## Campaign Update CA#9992

Subject: The Dinette Flipdown Support & Footrest  
Affects certain 2022 Unity U24TB motorhomes

# SOP05830

## QAAR 9992 Reinforce the U241B/TB PS/DS dinette flip down

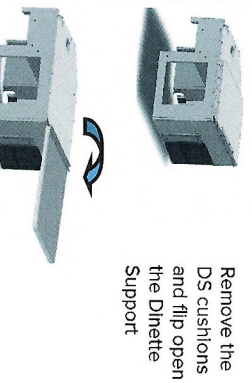
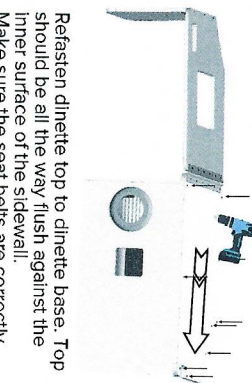
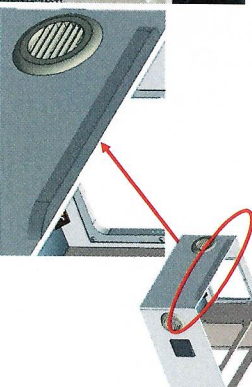
The dinette flipdown support & footrest assembly does not have adequate support when in the sleep position.

Drill five 11/64" holes from the inside of the dinette base:

- 7mm down from the top
- From the front inner surface: 85mm, 185, 285, 385, 485mm

Screw the Flip Down Support B077462 flush to the top of the PS Dinette Cabinet Base.

Push the Dinette top all the way against the sidewall. There should be approximately 4mm of the dinette cabinet base showing. This is intended to be the support for the Dinette Support.

Remove the Passenger Side seat cushions and flip the Footrest into the sleep position.  
i.e. backrest becomes foot support

Remove each of the 12 drywall screws that secure the dinette seat base.

Refasten the dinette top back onto the dinette base.  
Make sure the seat belts are correctly routed through the tops.

Remove the DS cushions and flip open the Dinette Support
